# **Gordonbush Extension Wind Farm**

EIA Report Addendum

June 2019

Volume 1: Non-Technical Summary

**Figure 2**  
**Proposed Varied Development - Addendum**

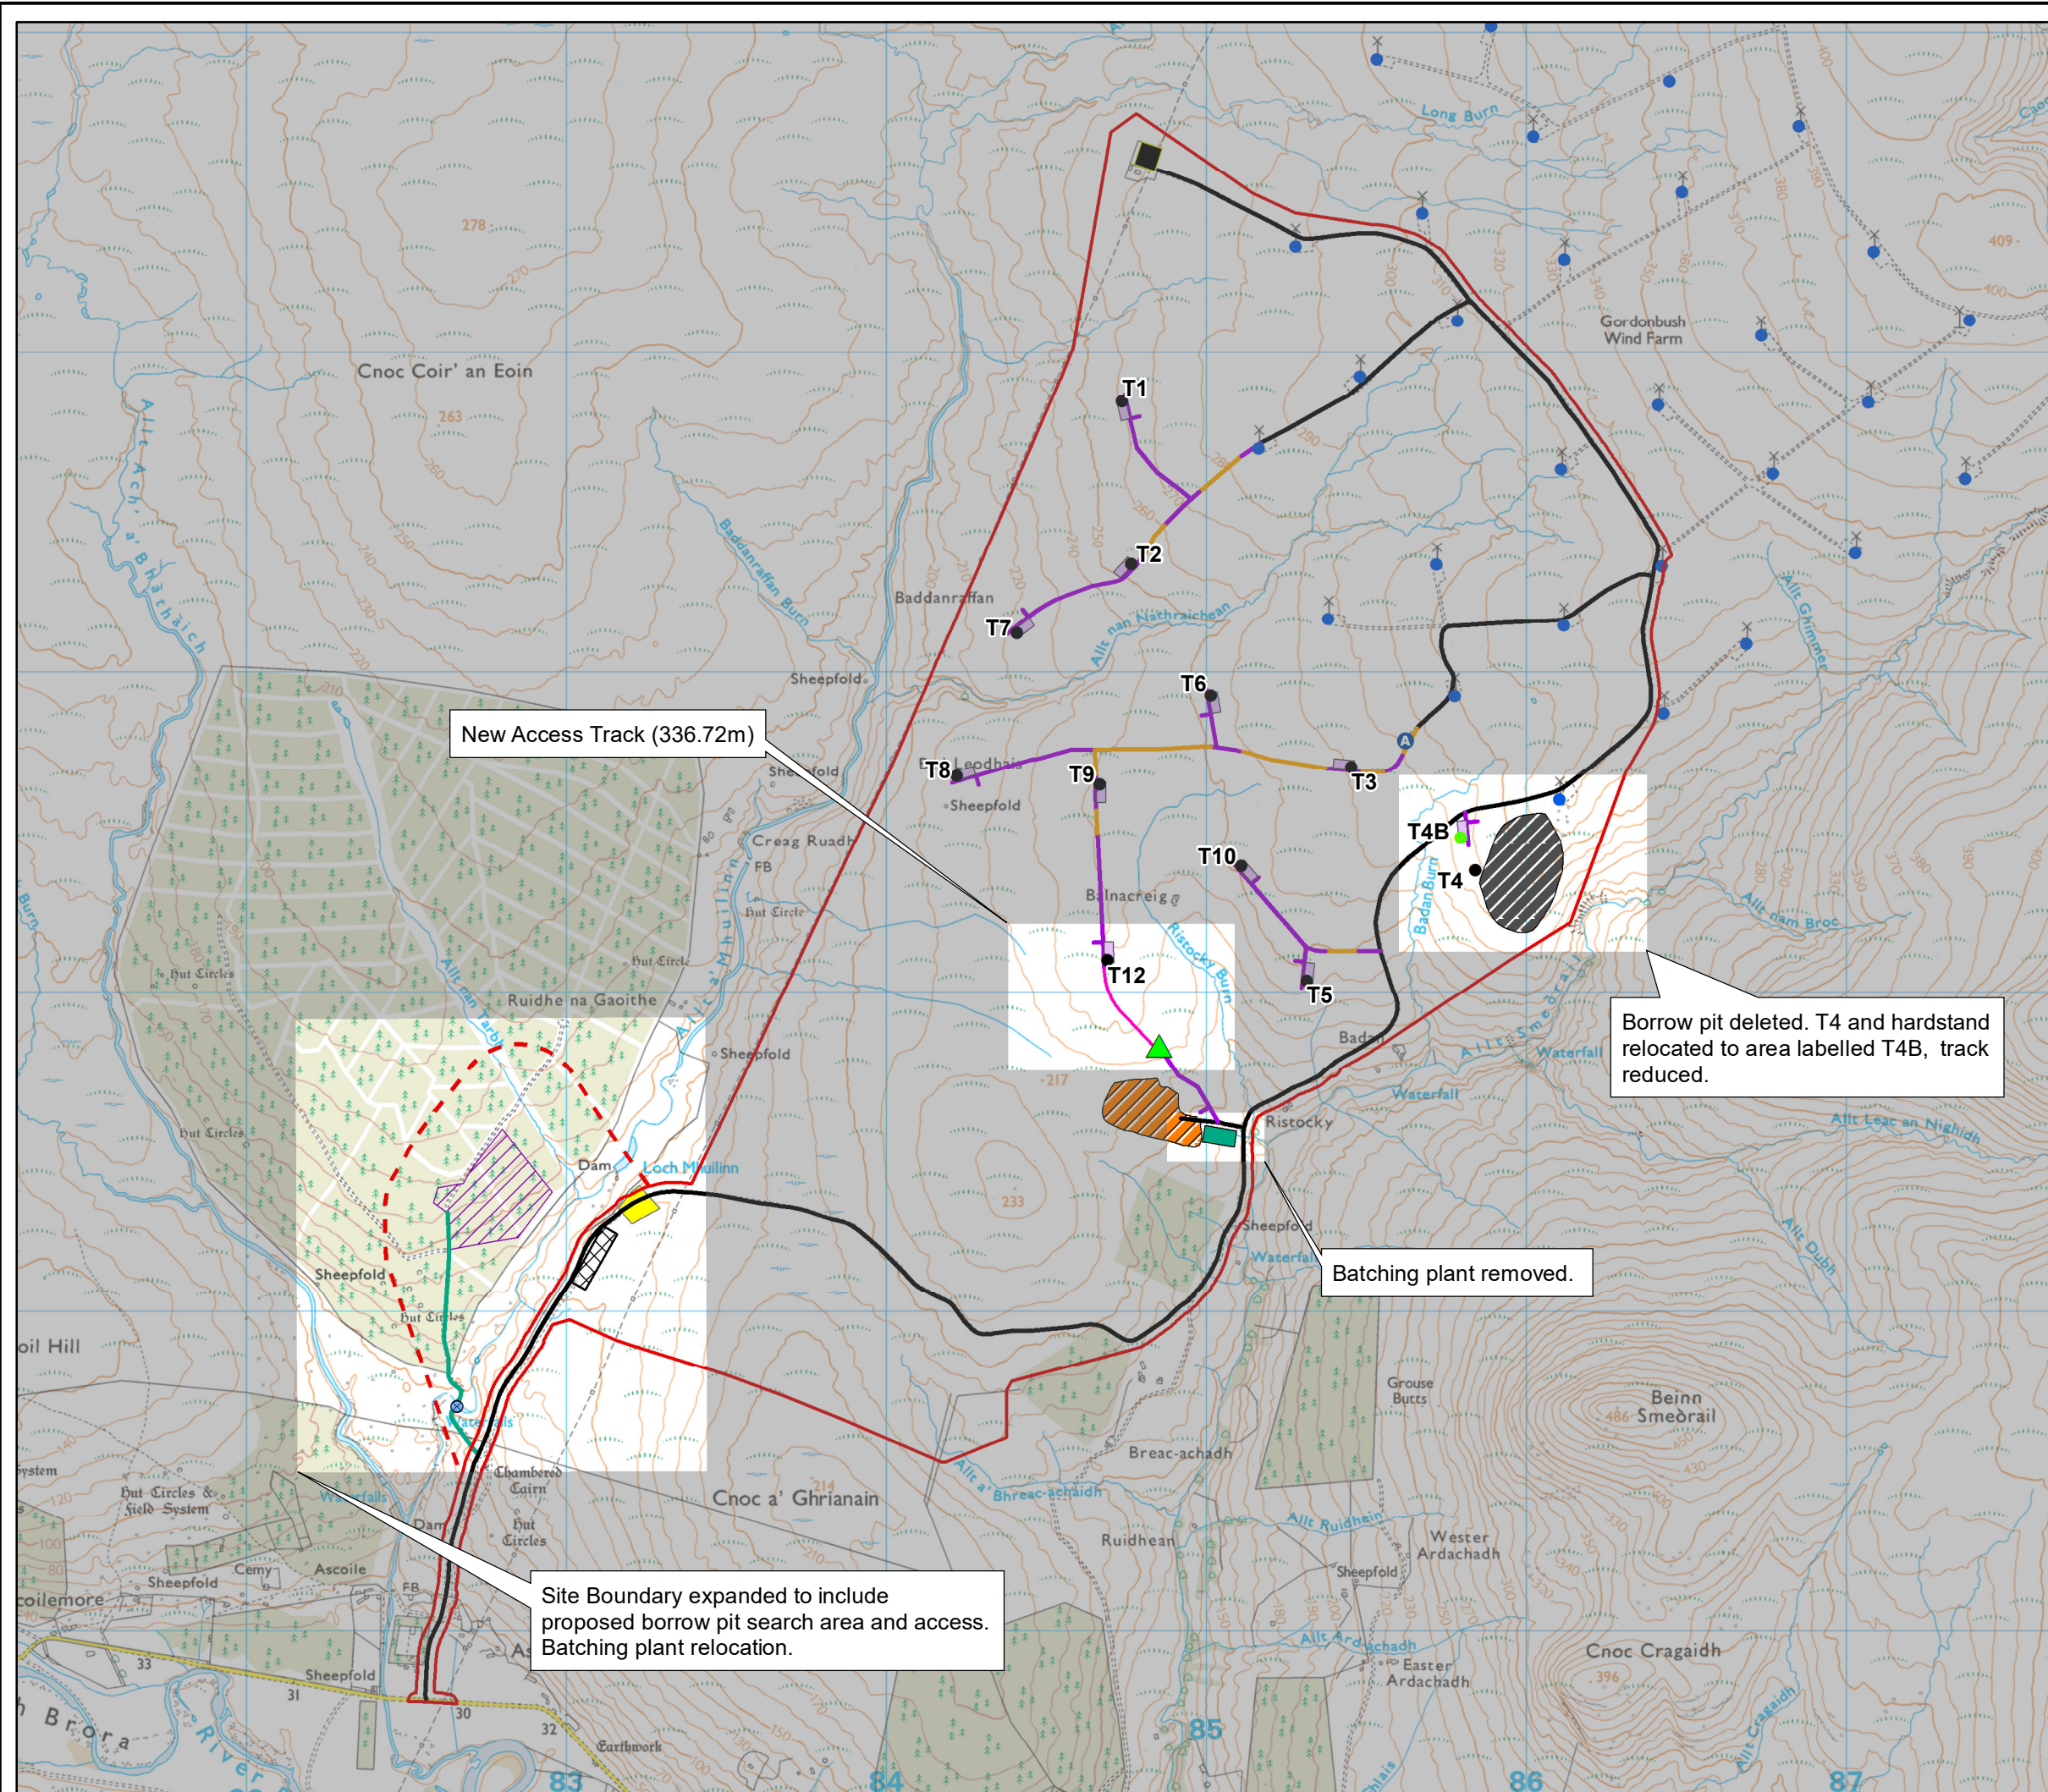
- 1.2.1 Following submission of the section 36C application in January 2019, ground investigation works have been undertaken which has resulted in a further change to the application. These changes, referred to as the ‘Proposed Varied Development (Addendum)’ comprise: relocation of Turbine 4 by approximately 113m (T4b) and deletion of associated access track length; removal of one borrow pit search area; inclusion of one new borrow pit search area and associated construction access; relocation of the concrete batching plant; and construction of an additional circa 330m of access track. There are no changes in respect of tip height or capacity.

- 1.2.2 An amendment to the site boundary has also been made to accommodate the new borrow pit search area. The proposed changes, including the amended site boundary, are shown on Figure 2: Proposed Varied Development - Addendum.

- Relocation of Turbine 4 (T4) by approximately 113m, and renaming of Turbine to T4b;
- Deletion of Borrow Pit 2 Search Area;
- Inclusion of new Borrow Pit 3 Search Area, including use of existing access and temporary watercourse crossing (bailey bridge or similar);
- Relocation of Batching Plant; and
- Construction of an additional access track from T12 to Lidar/Borrow Pit 1.

**Figure 3**  
**Site Layout**

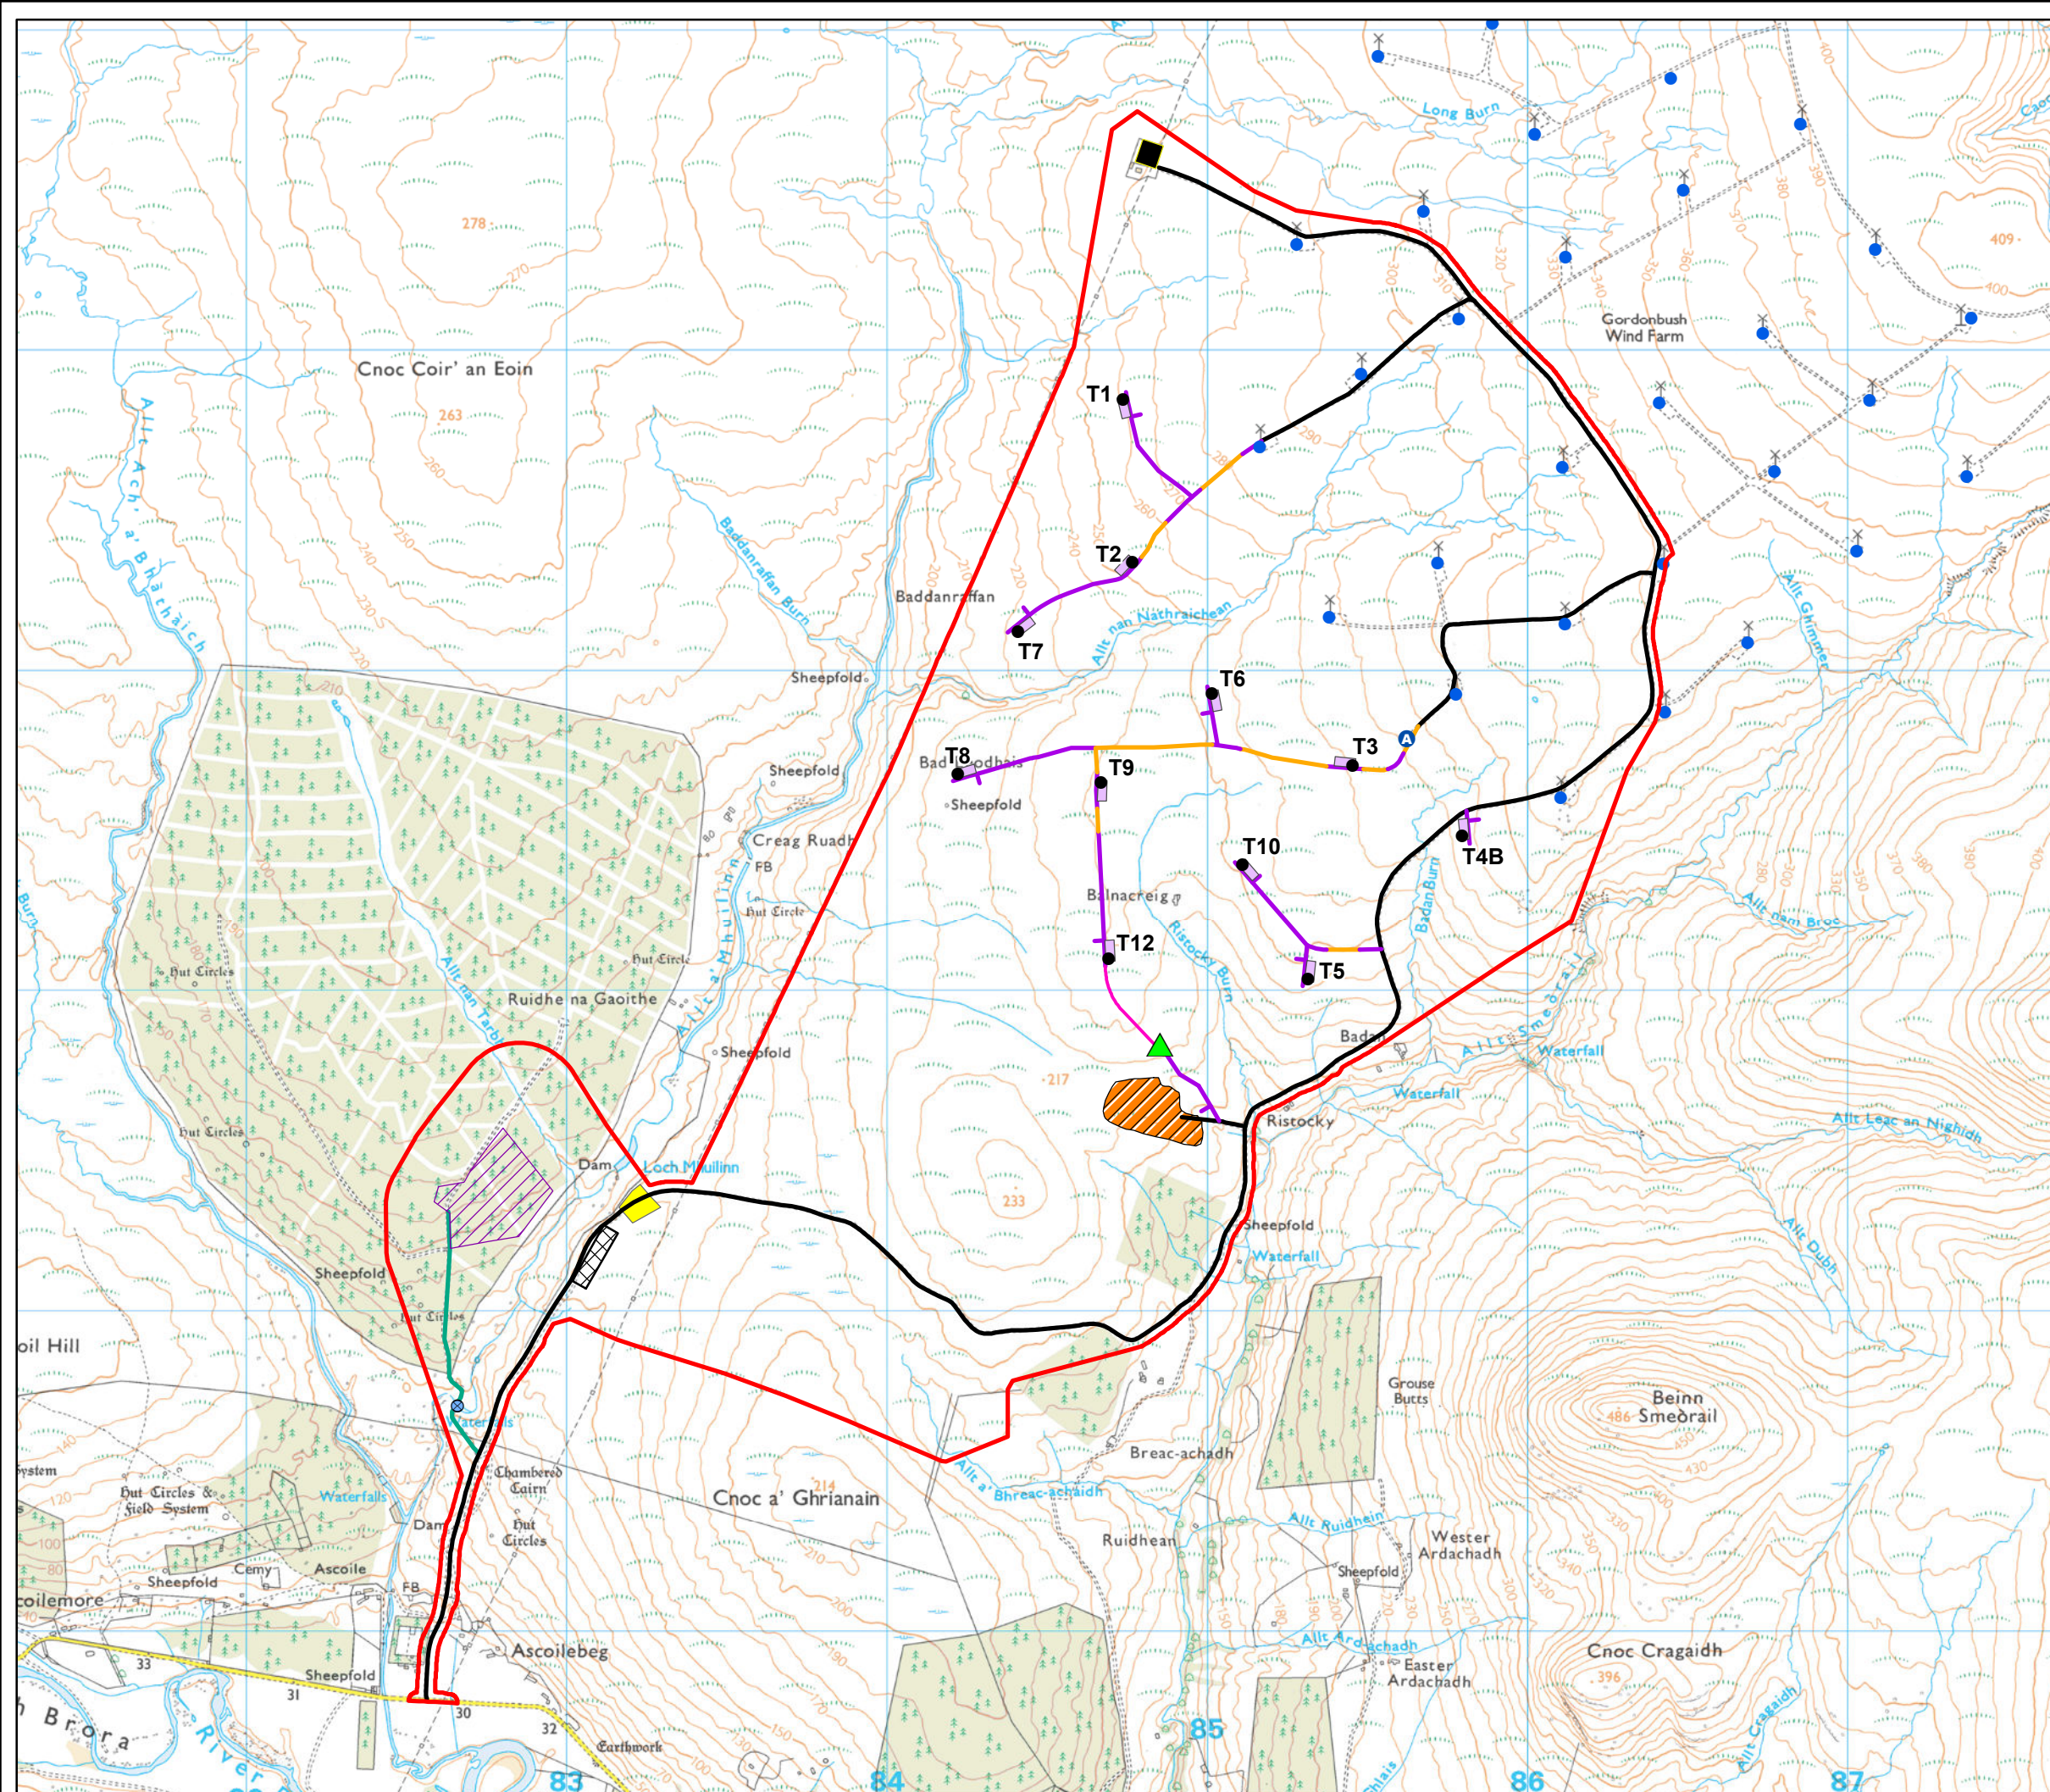
2.1.3 The layout of the Proposed Varied Development (Addendum), reflecting the Addendum changes, is shown on Figure 3: Site Layout. The revised approximate central grid reference is 284700, 913400, as the site boundary has been extended to the west to include a new borrow pit search area, and associated access.
